**ADDENDUM NO. 1**

**MLK ELEMENTARY SCHOOL  
TRANSITIONAL KINDERGARTEN  
BAKERSFIELD CITY SCHOOL DISTRICT**

**Project No.: 5593  
DSA File No. 15-6  
DSA App No. 03-123900  
December 20, 2024**

Sheet No.:  
**A2.01**

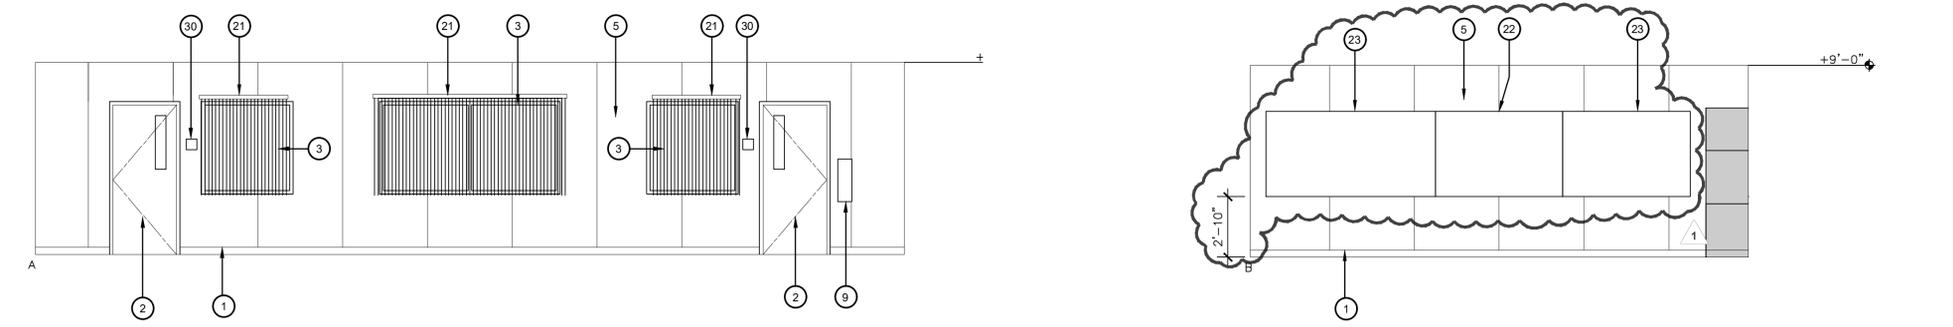
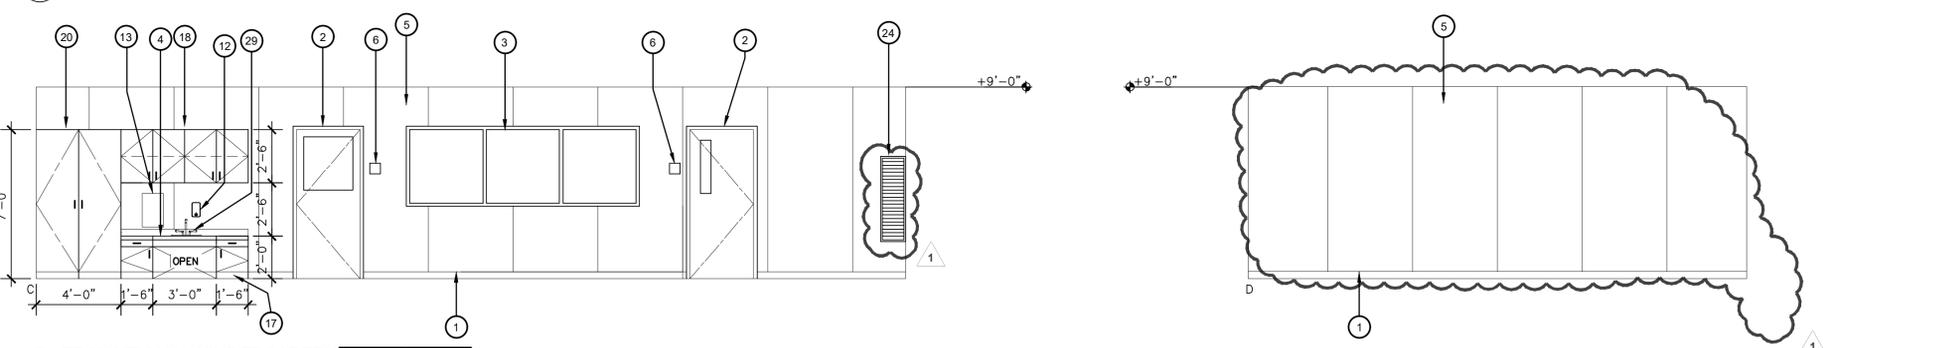
- 1-08 **DRAWING, SHEET A2.01 – FLOOR PLAN:** Note the following changes (See A2.01 addendum 1 drawing):
  - 1. Electrical and low voltage panels in room TK 2.1 have been changed. See keynotes 25 and 31 and Interior Elevations 5/A5.01
  - 2. Add IDF cabinet to room TK2.1. See keynote 31.
  - 3. Add tall cabinets to rooms TK1 and TK2. See keynote 30.
  - 4. Marker board and smart board have been moved to the East wall in room TK1 and TK2. See keynote 4 and 5.
  - 5. VCT has been modified in TK1 and TK2. See keynote 10.
  - 6. Change markerboards to 6'-0" long. See keynote 4
  - 7. Keynotes 1 and 9 have been modified.
- 1-09 **DRAWING, SHEET A5.01 – INTERIOR ELEVATIONS:** Note the following changes (See A5.01 addendum 1 drawings):
  - 1. Elevation “B” and “D” TK 1 and TK2.:

Sheet No.:  
**A5.01**

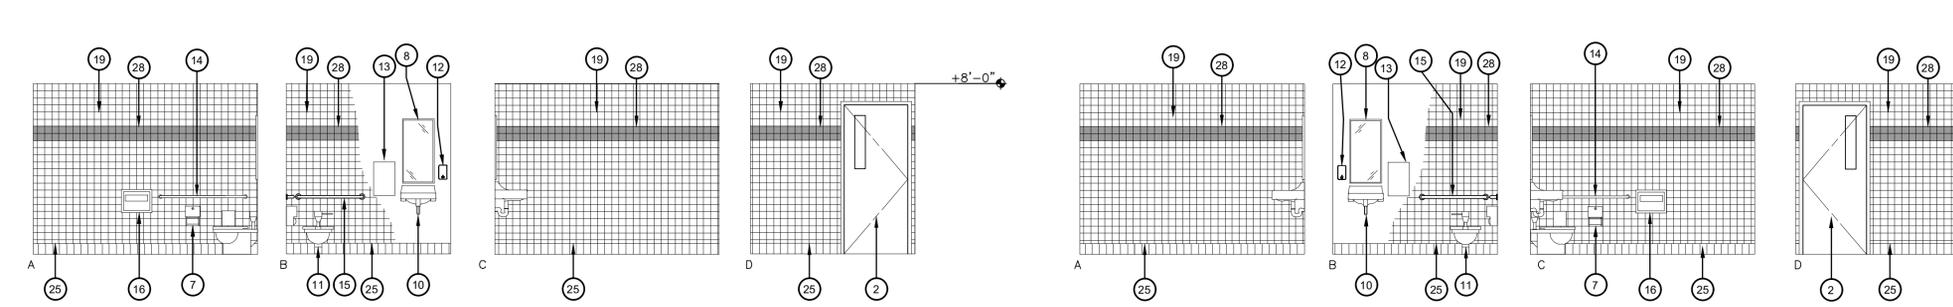
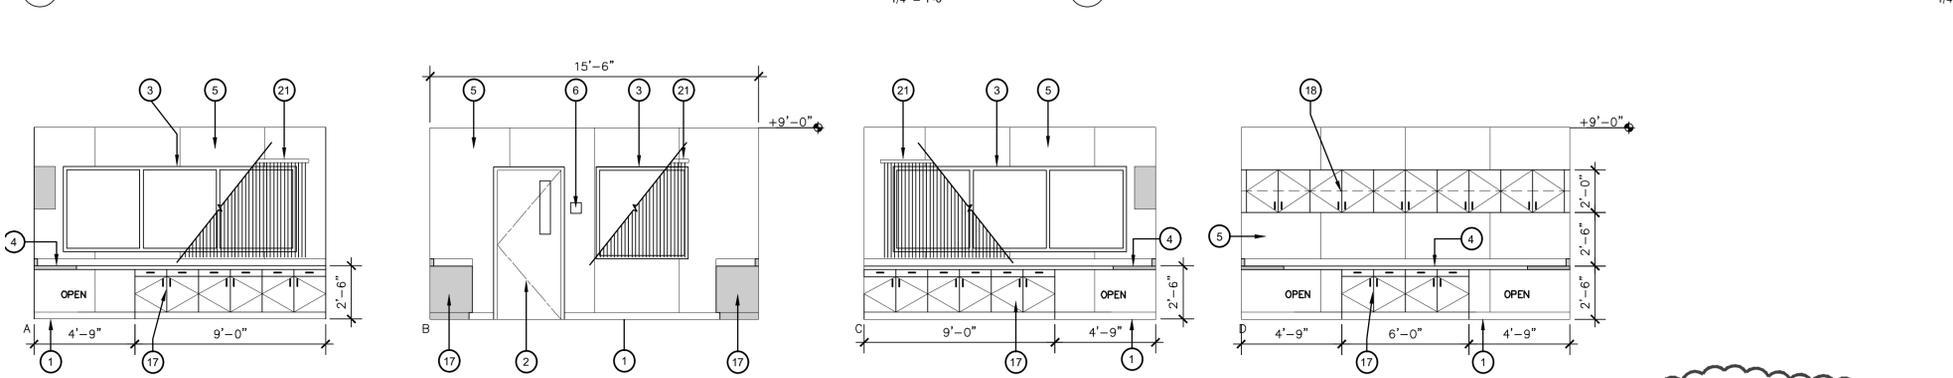
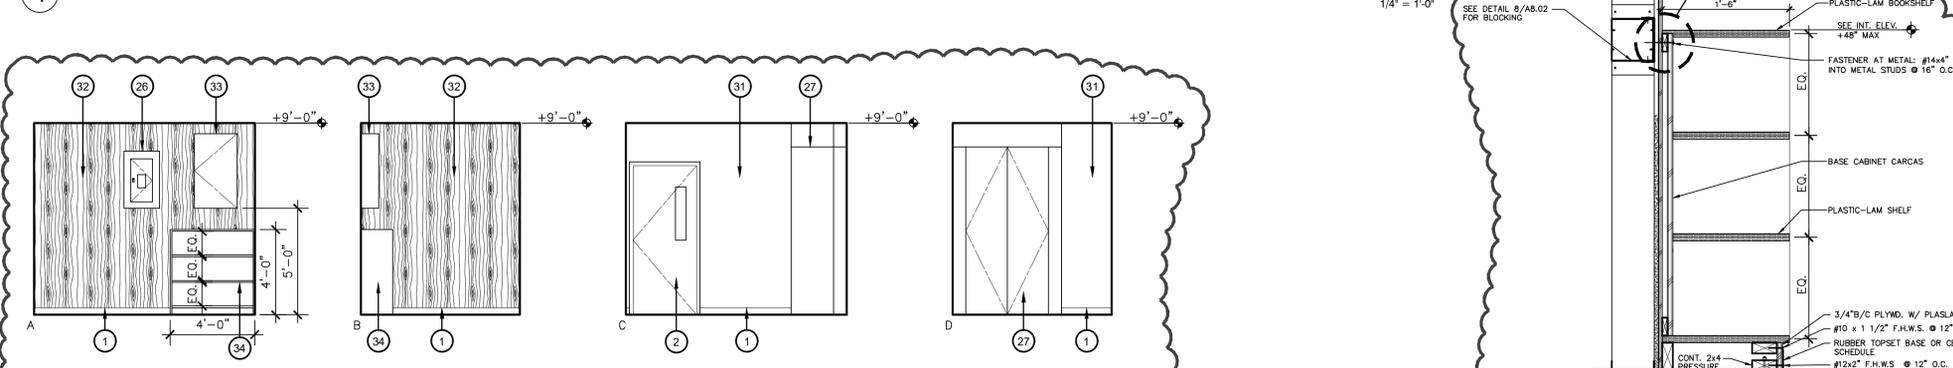
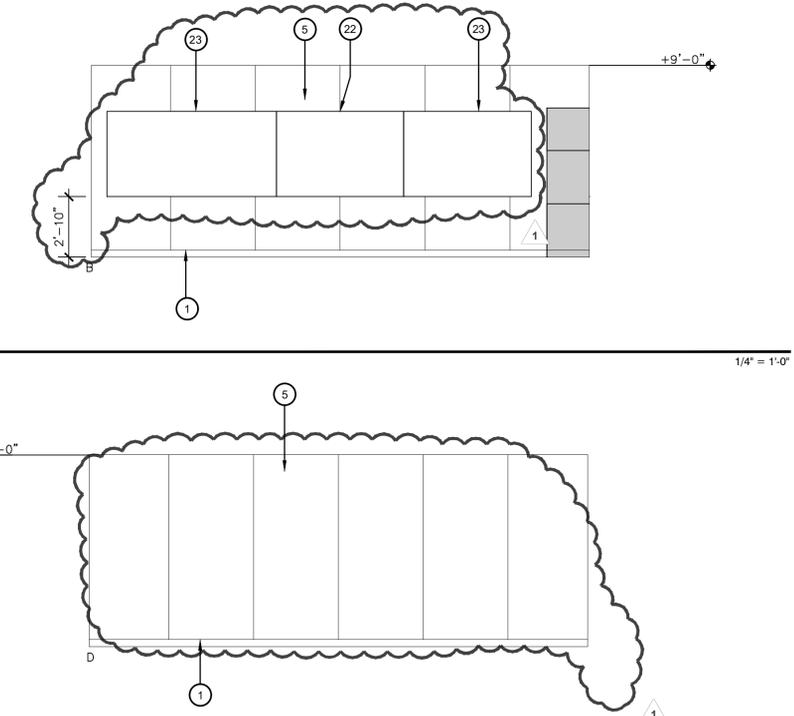
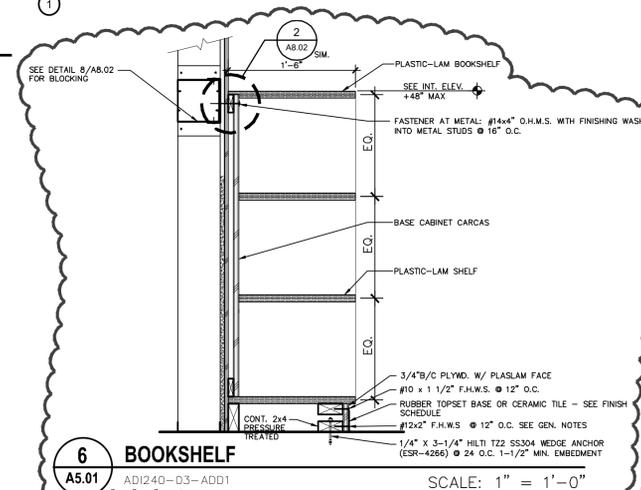
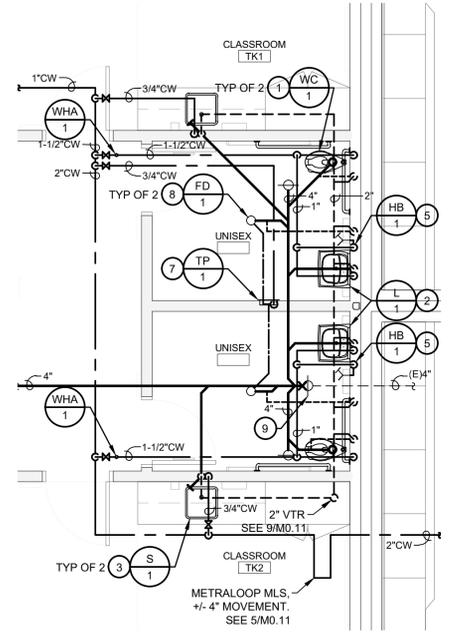
2. Markerboards and smartboard have been modified
3. Add elevations to storage room TK2.1

Sheet No.:  
**M2.12**

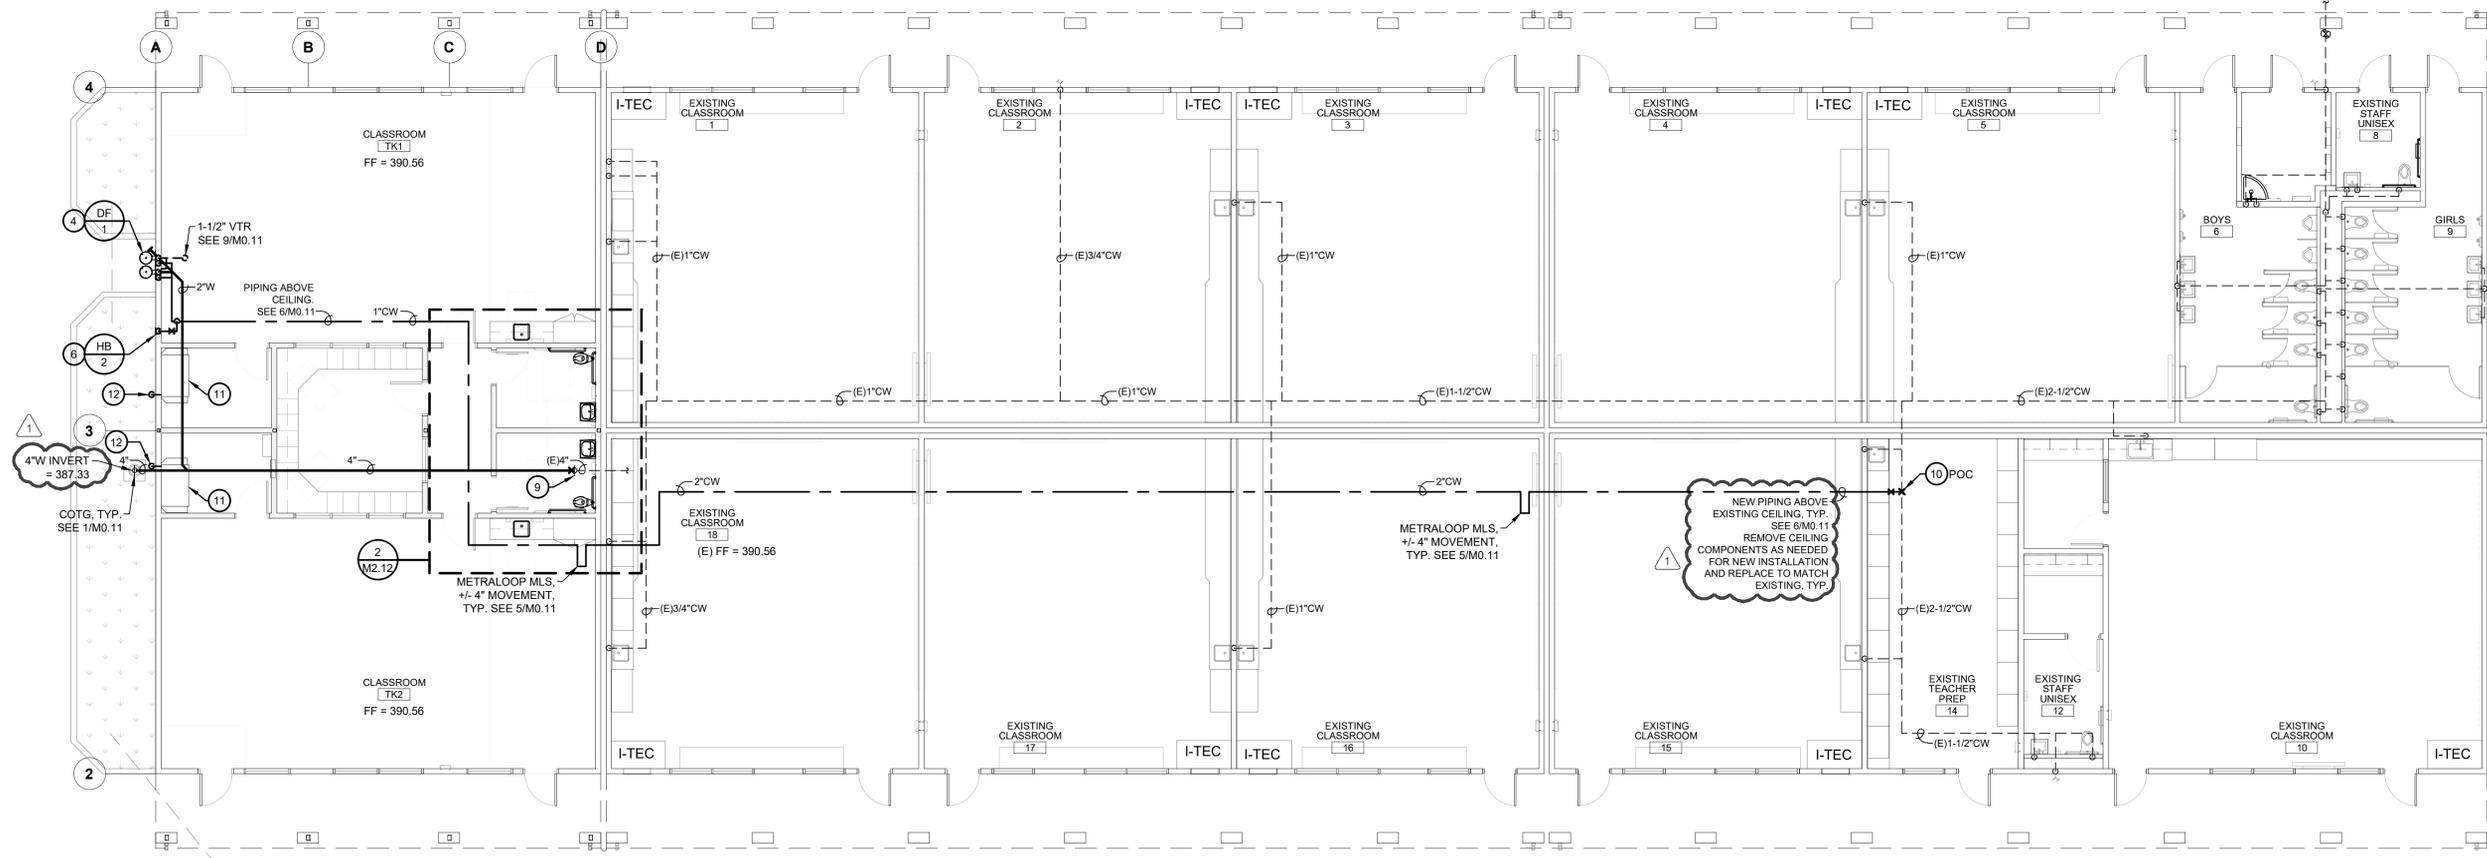
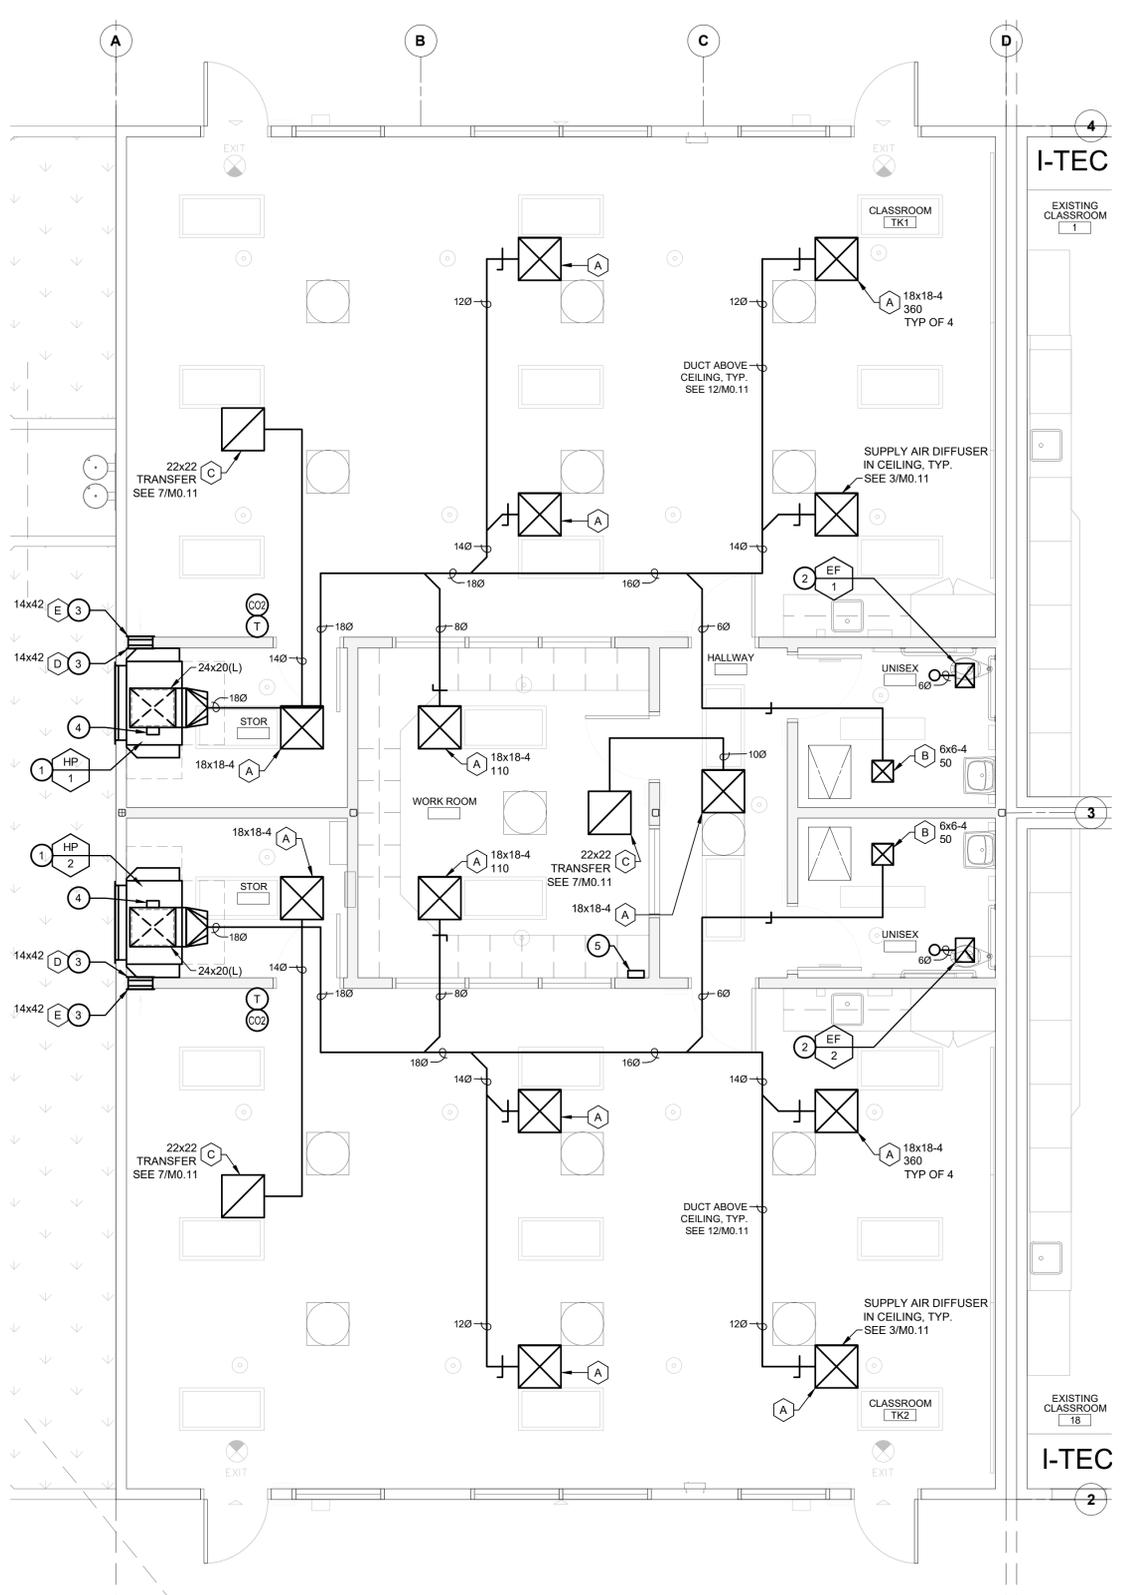
**1-10 DRAWING, SHEET M2.12 – MECHANICAL PLAN – PLUMBING:** Note the following changes (See M2.12 addendum 1 drawing):

1. Modify keynote 3.
2. Add note in room 15.

**1 MECHANICAL PLAN - HVAC**  
M3.11 TRANSITIONAL KINDERGARTEN SCALE: 1/4" = 1'

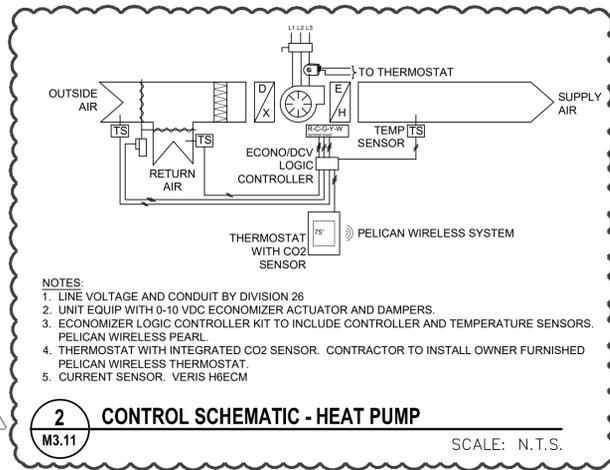
**1-11 DRAWING, SHEET M3.11 – MECHANICAL PLAN - HVAC:** Note the following changes (See M3.11 addendum 1 drawing):

1. Detail 2/M3.11 has been added.
2. Keynote 1 has been modified.

Job No.: **5593**  
 Sheet No.: **E1.00**  
 Release: ADDENDUM 1

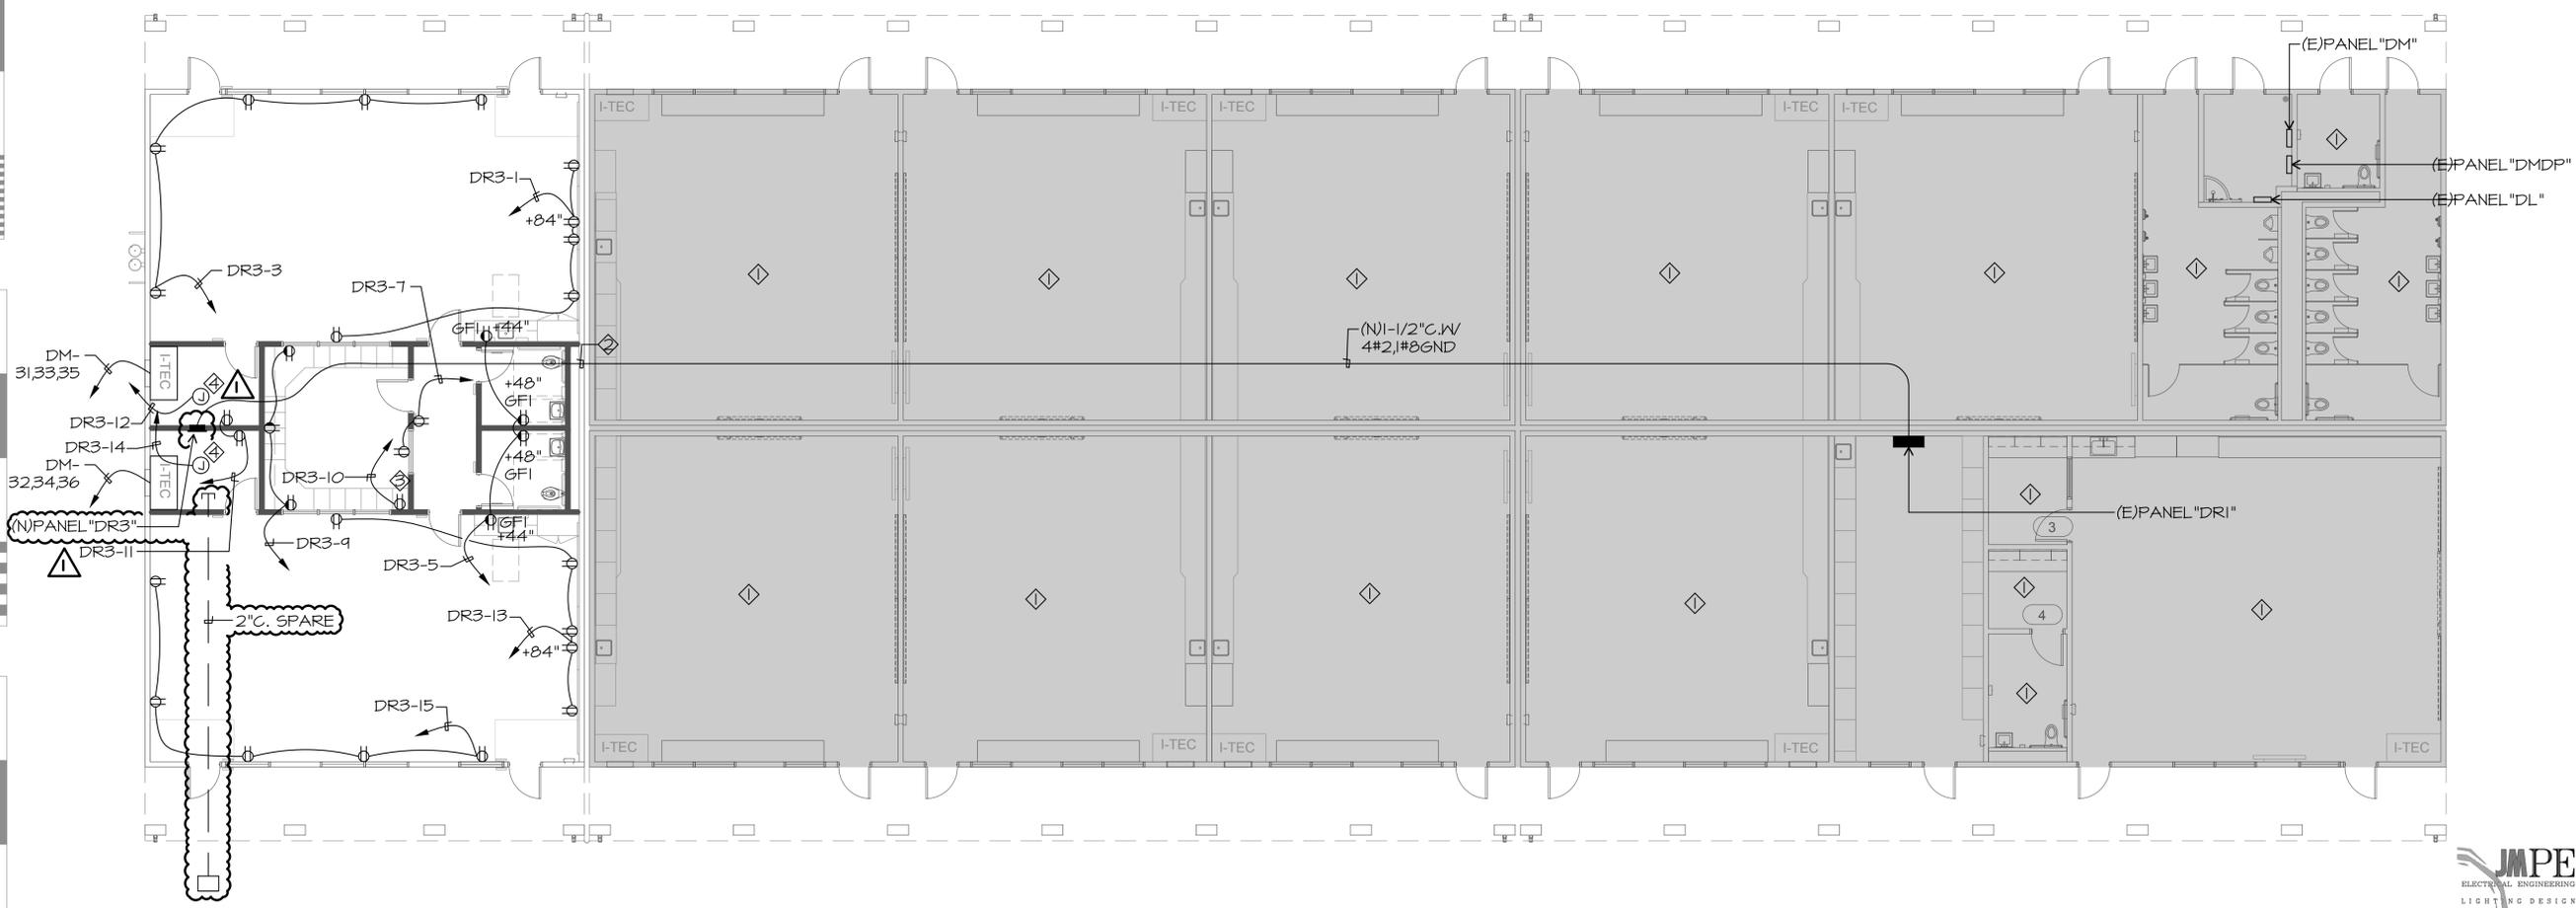
**1-12 DRAWING, SHEET E 1.00 – ELECTRICAL FLOOR PLAN:** Note the following changes:

1. Relocate electrical panel “DR3”.
2. Add spare conduit and pull box.
